MODIFICATION REQUEST:
Mixed Residential and Retail Development
21 – 35 Treacy Street, Hurstville
Earljest Pty Ltd

Modification MP10_0101 MOD 1

Director-General's
Environmental Assessment Report
Section 75W of the
Environmental Planning and Assessment Act 1979

September 2012

Figure 3: Proposed Staging

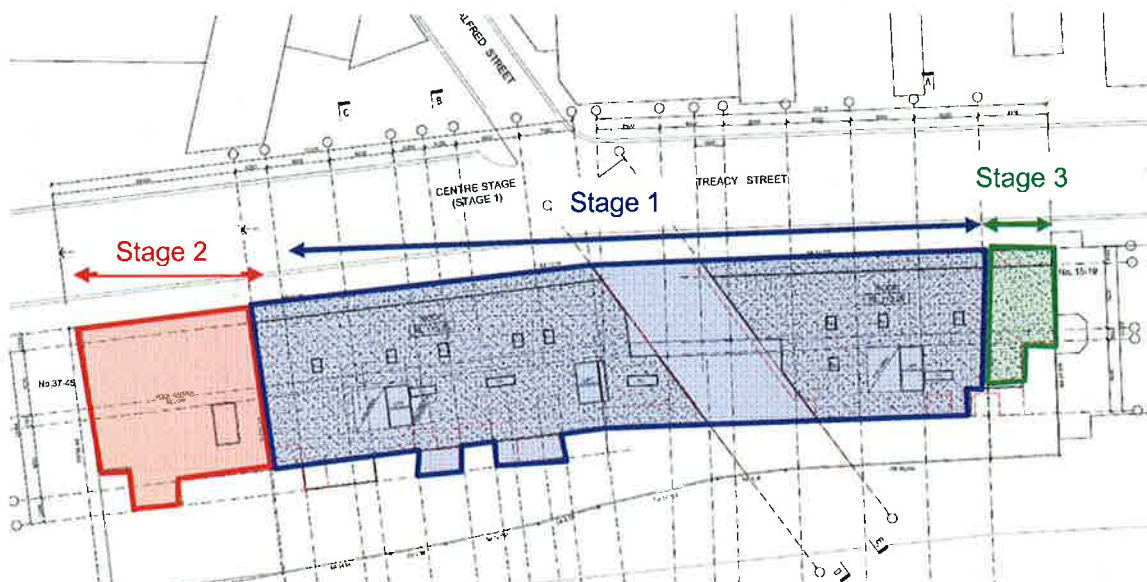
The proposed modification seeks to include the specific staging of the development, as part of the approval. It is proposed to split the development into 3 stages including Stage 1; Central portion of the development, Stage 2; western portion of the development and Stage 3; the eastern portion of the development. It is the intent of the staging of the development that each stage can be considered as separate development applications. The proposed staging is illustrated in **Figure 3**.
